DEVELOPMENT REVIEW BOARD PANEL A AGENDA

2. [Resolution No. 405 Boones Ferry Gas Station. The applicant is requesting approval of a Stage I Preliminary Plan Modification, Stage II Final Plan, Site Design Review, Class 3 Sign Permit, Sign Waiver and Type C Tree Plan for construction of a 2,999-square-foot convenience store with drive-thru and 12-pump fuel station.](#)

Exhibit A1
Staff Report
Wilsonville Planning Division
Boones Ferry Road Gas Station and Convenience Store

1 NORTH FUEL CANOPY ELEVATION
SCALE: 1/8" = 1'-0"

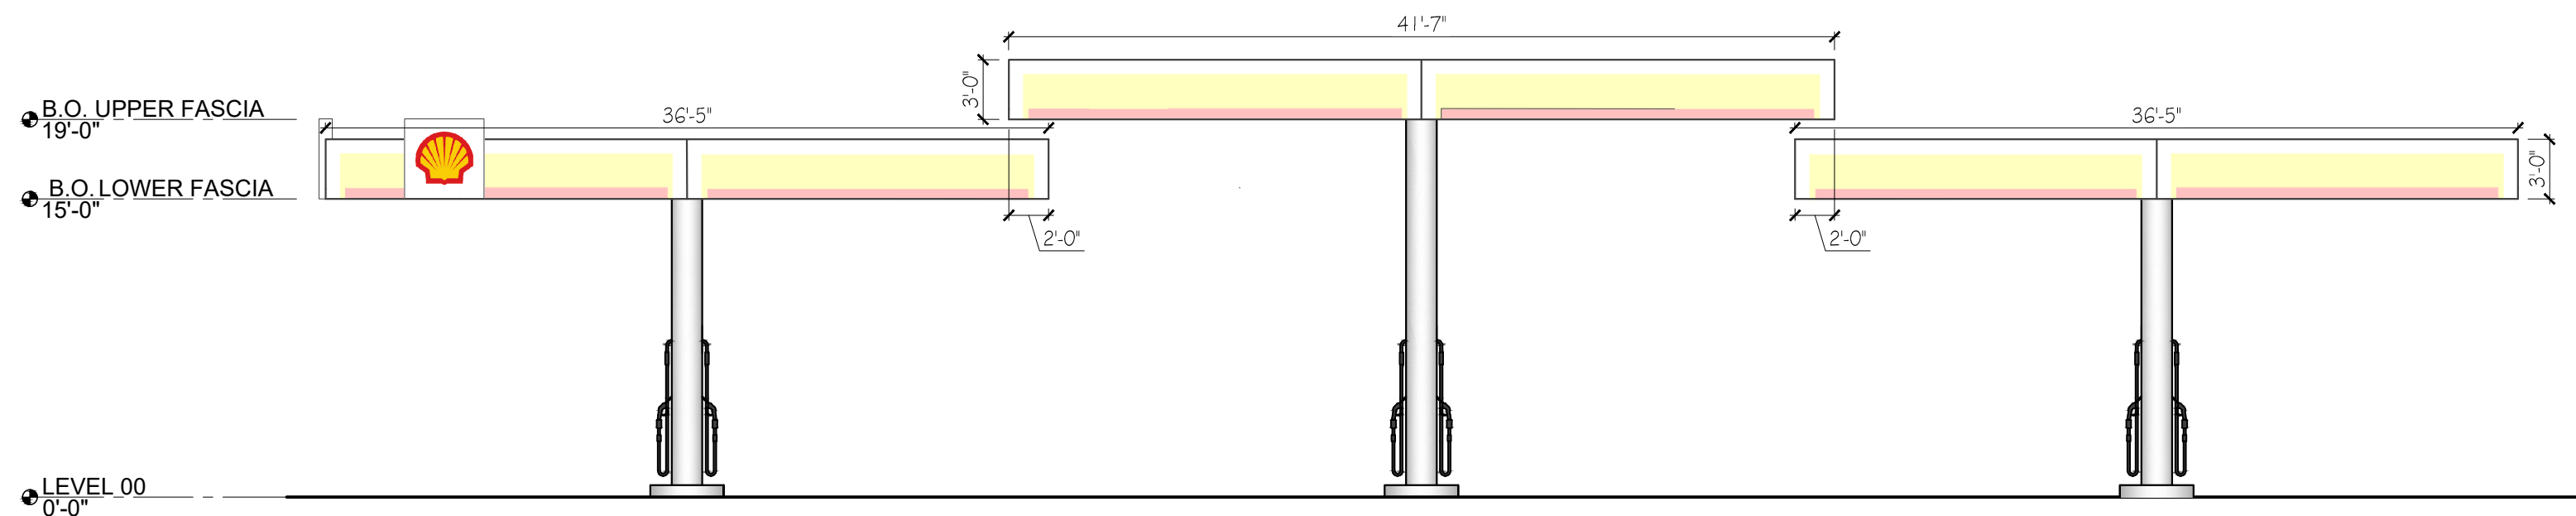
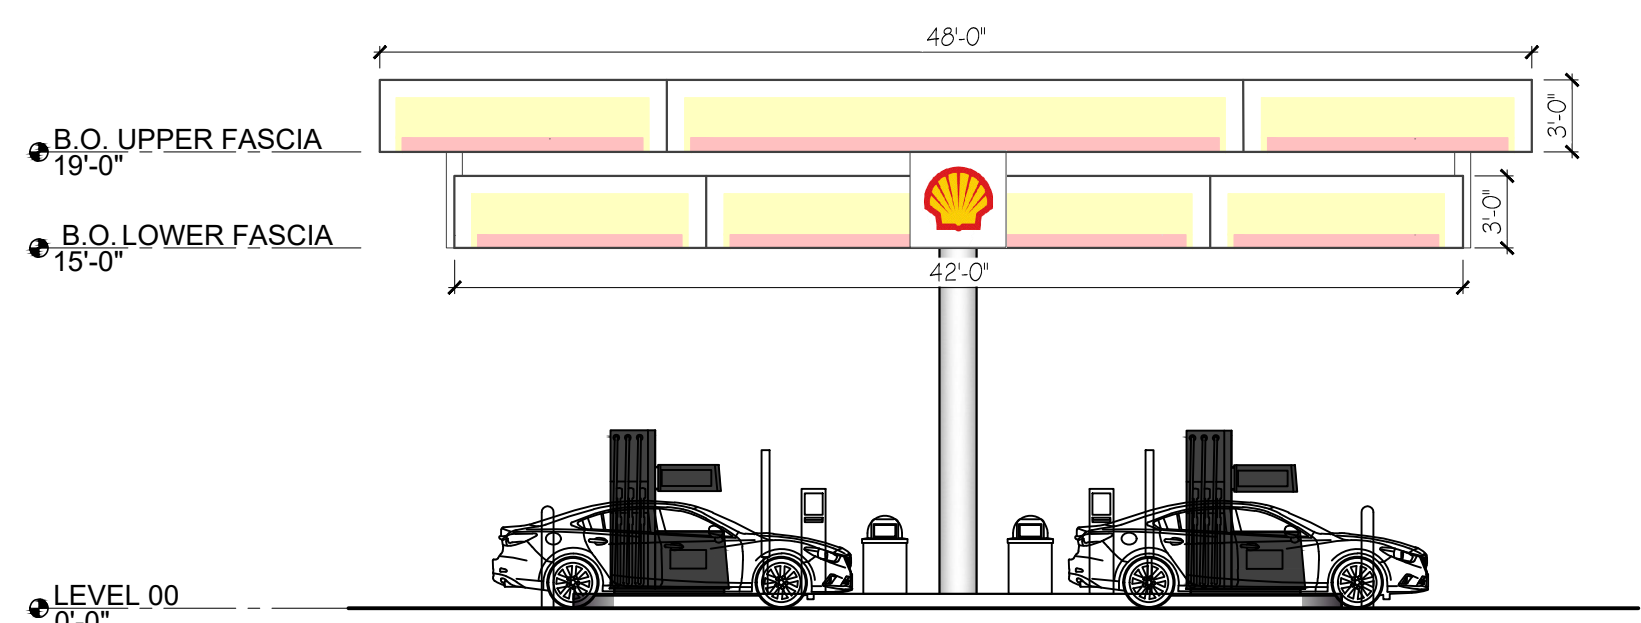
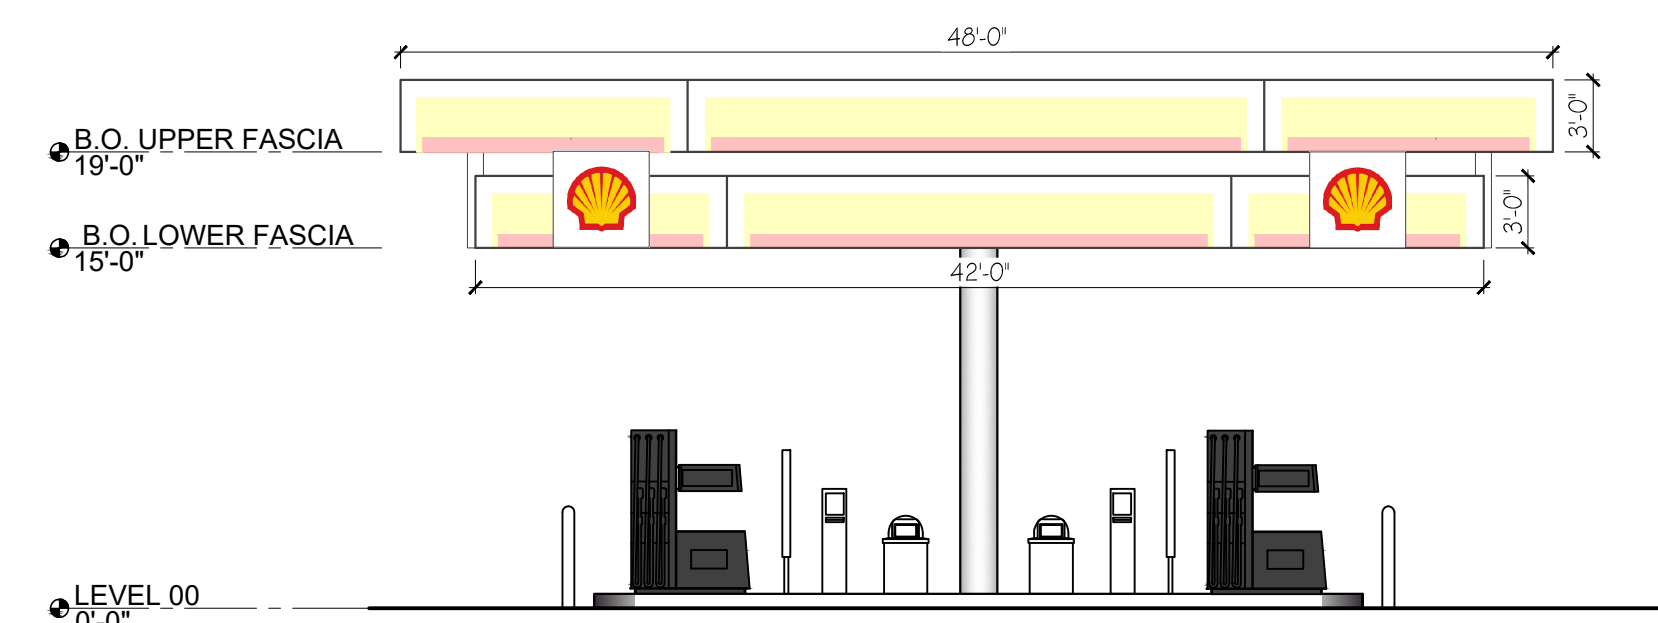
- A. Show elevation and dimensions of gas pump canopy and identify locations of proposed canopy signage. Sheet CS1 is illegible.
- *SEE REVISED SHEET CS1 WITH FUEL CANOPY ELEVATIONS, DIMENSIONS AND SIGNAGE LOCATIONS.*

S3
FREESTANDING SIGN DETAILS

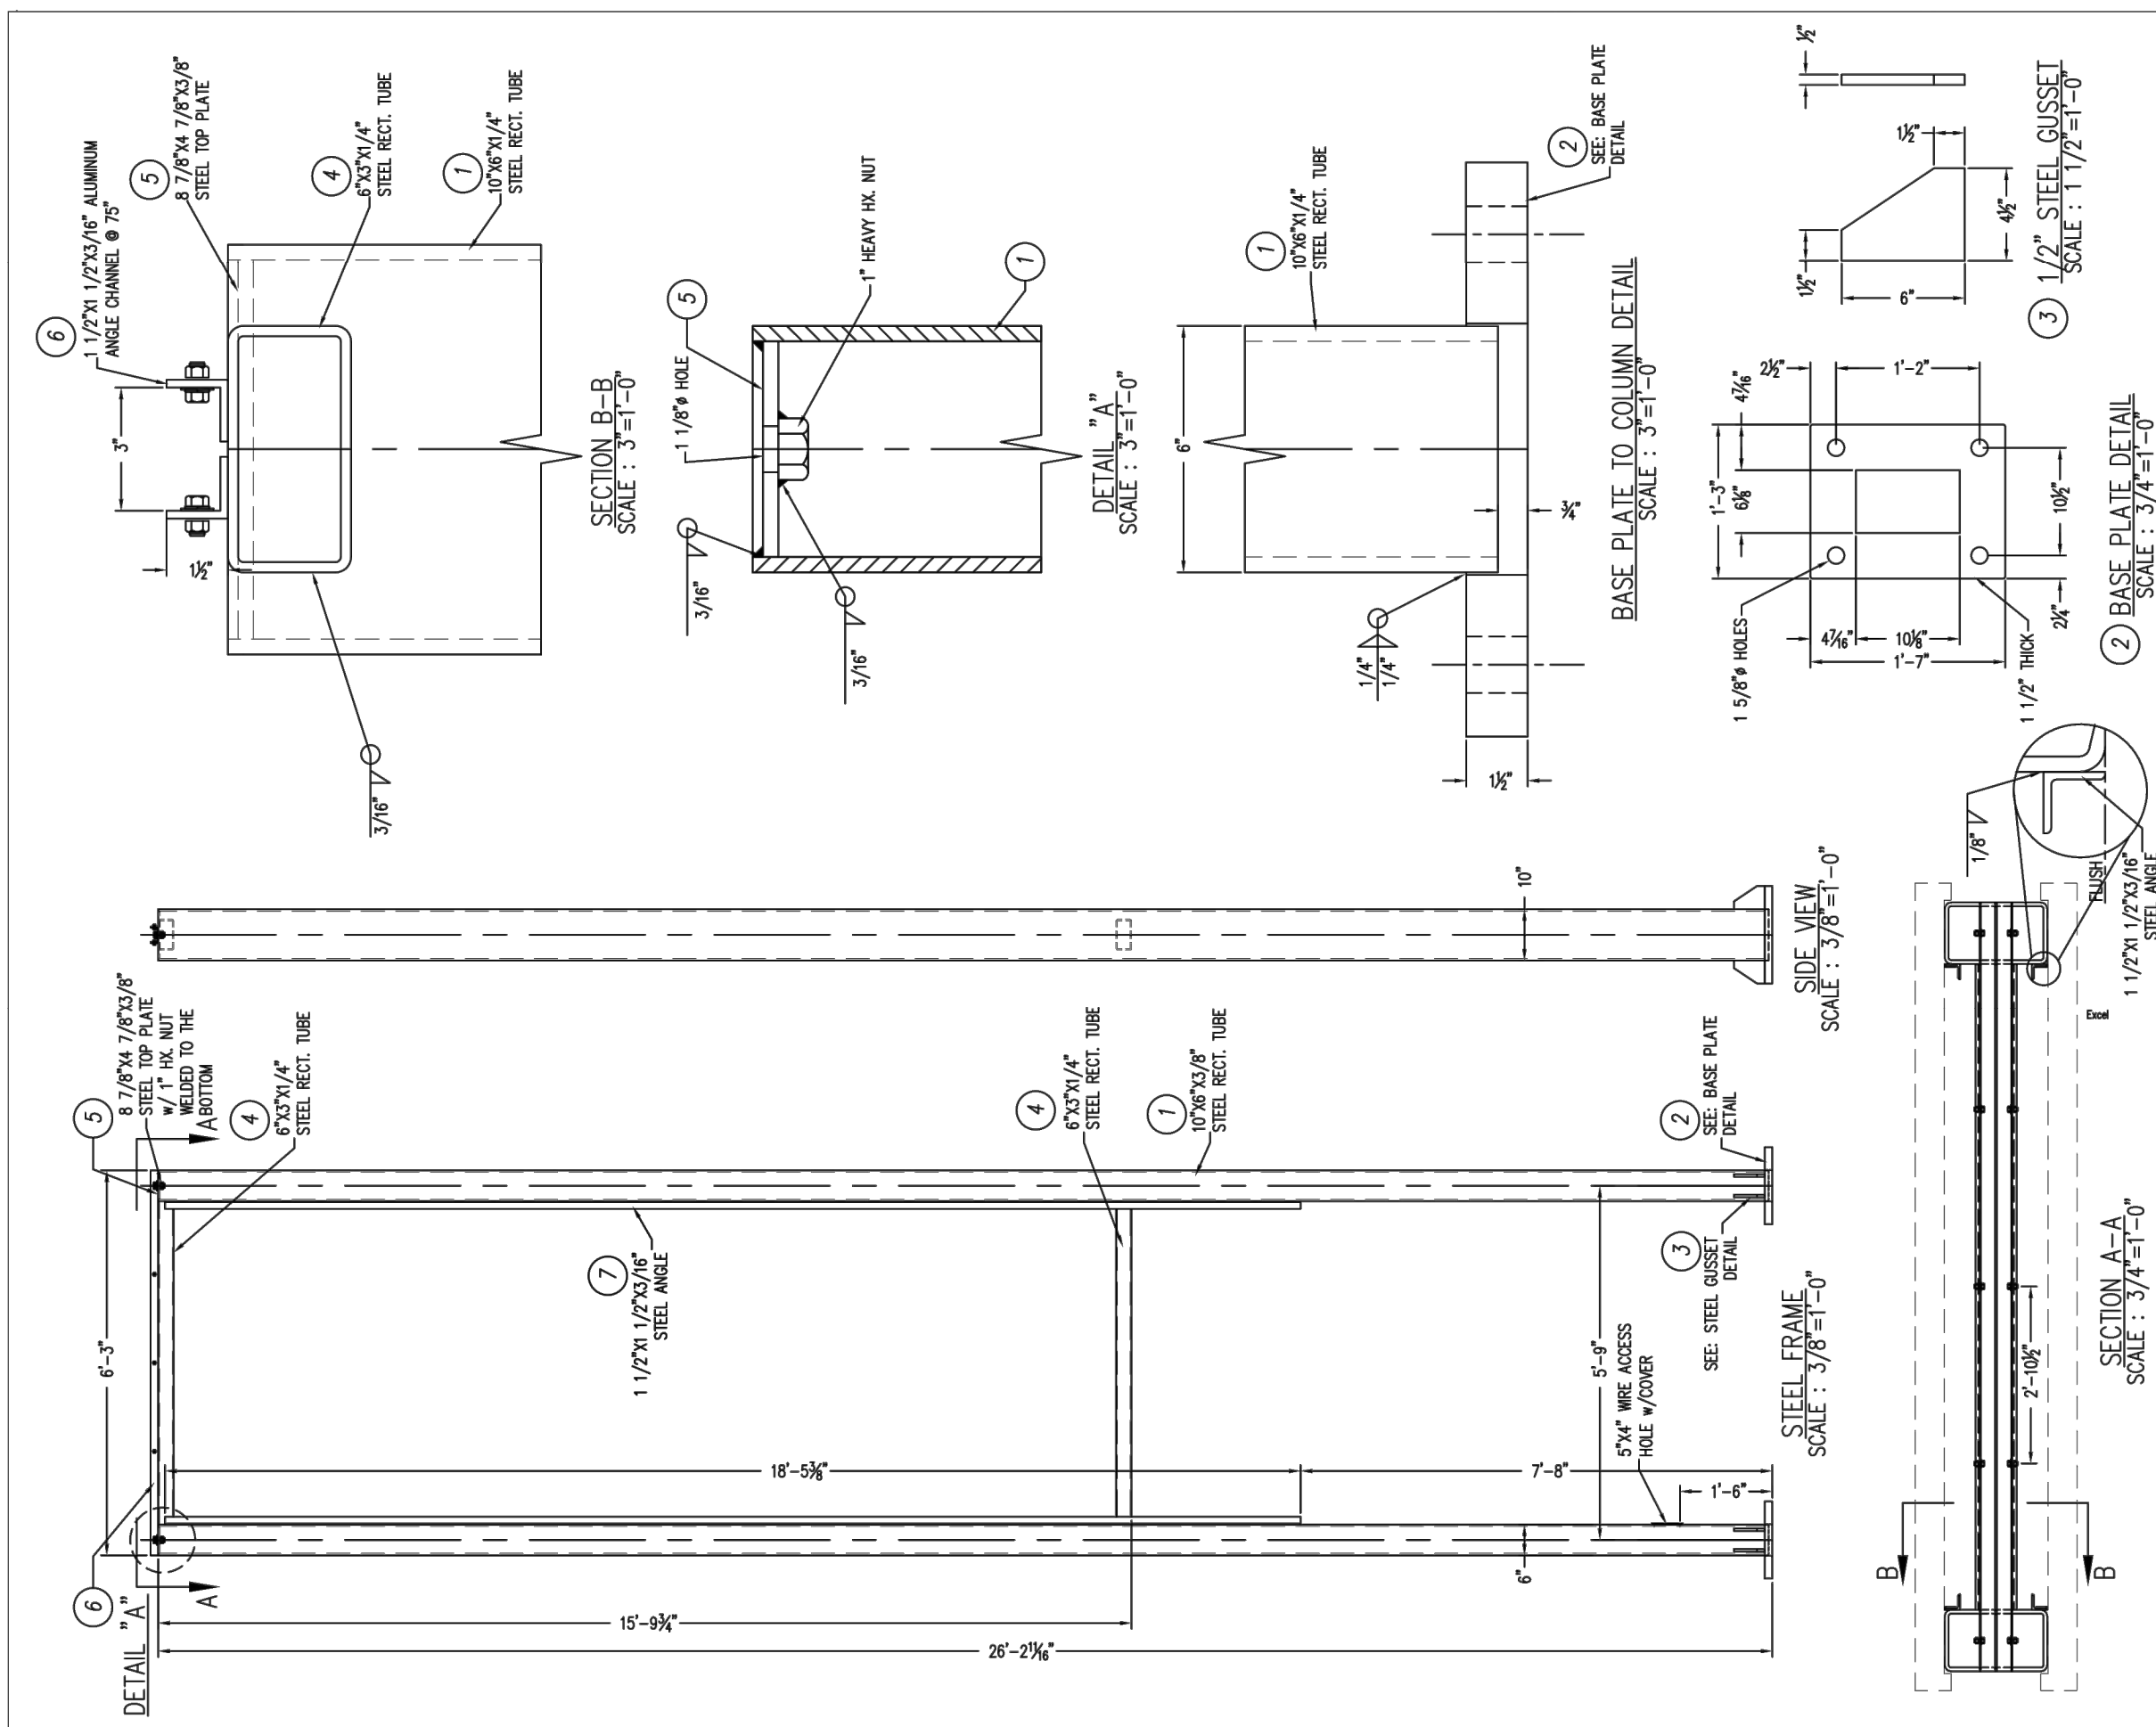
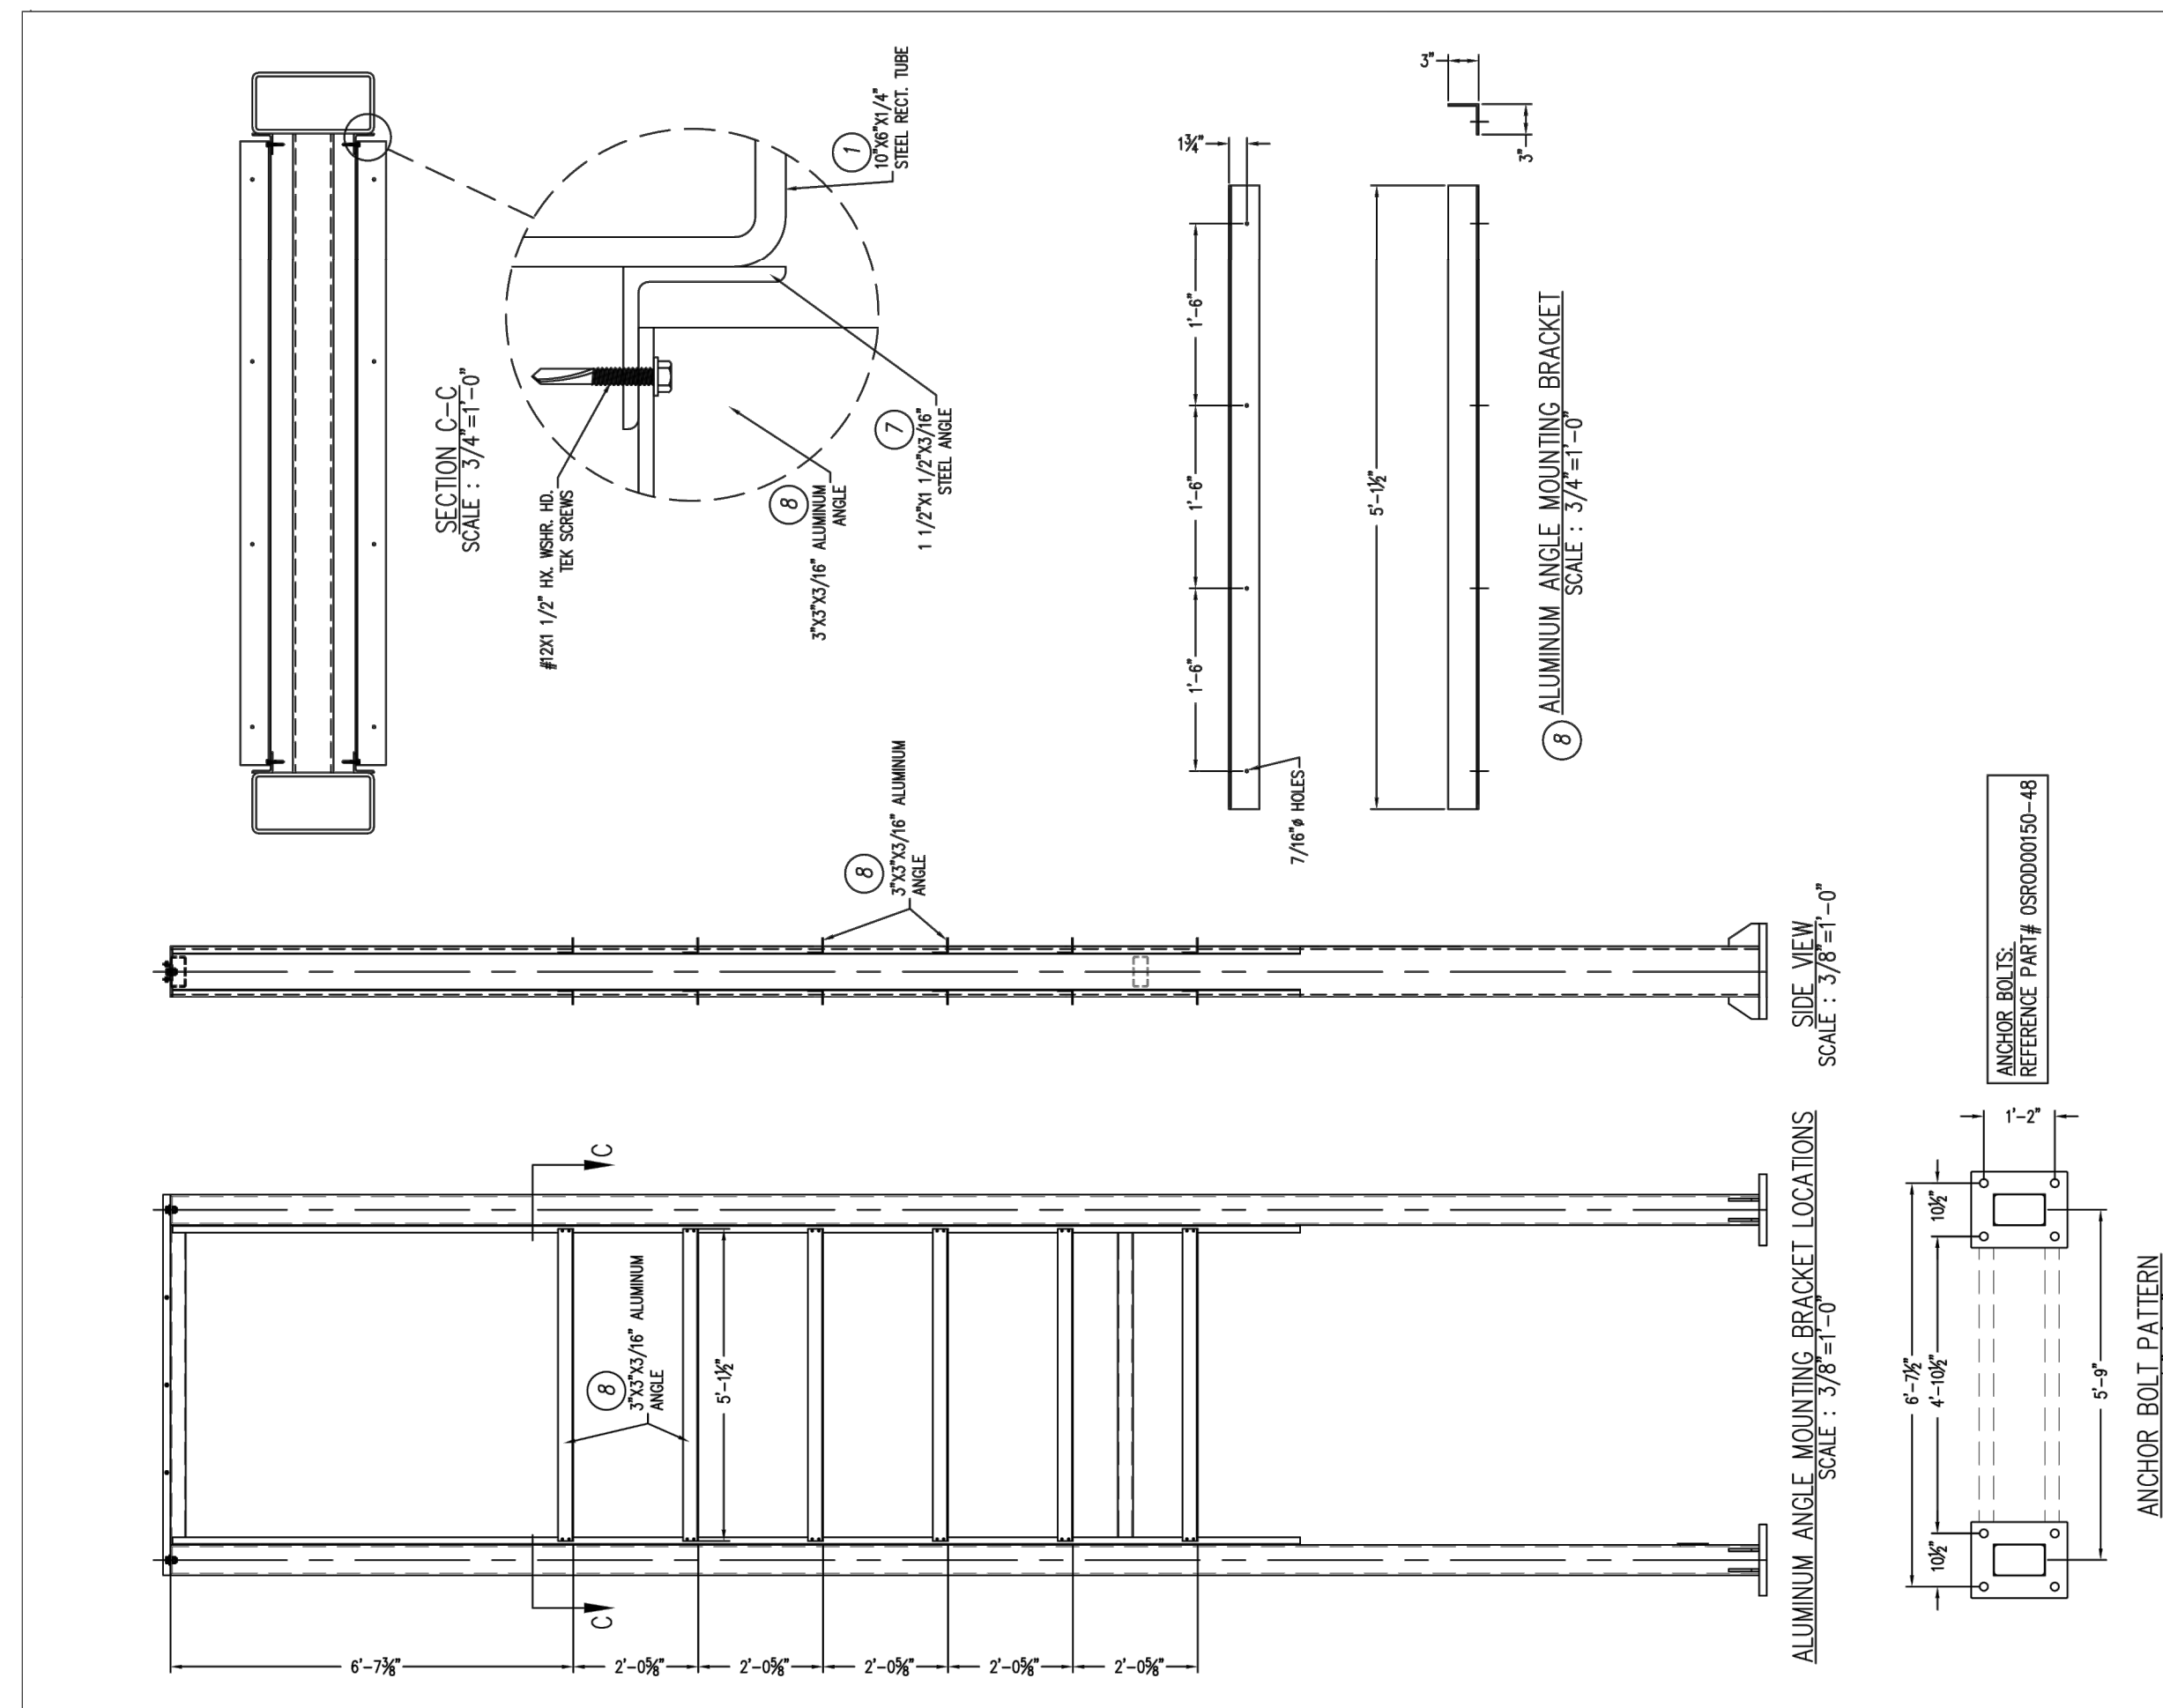
- *SEE REVISED SHEET S3.*
- C. Resubmit materials with consistent number for building square footage. Page 1 heading of revised narrative says 3,100 square feet, other references are to 2,999 square feet.
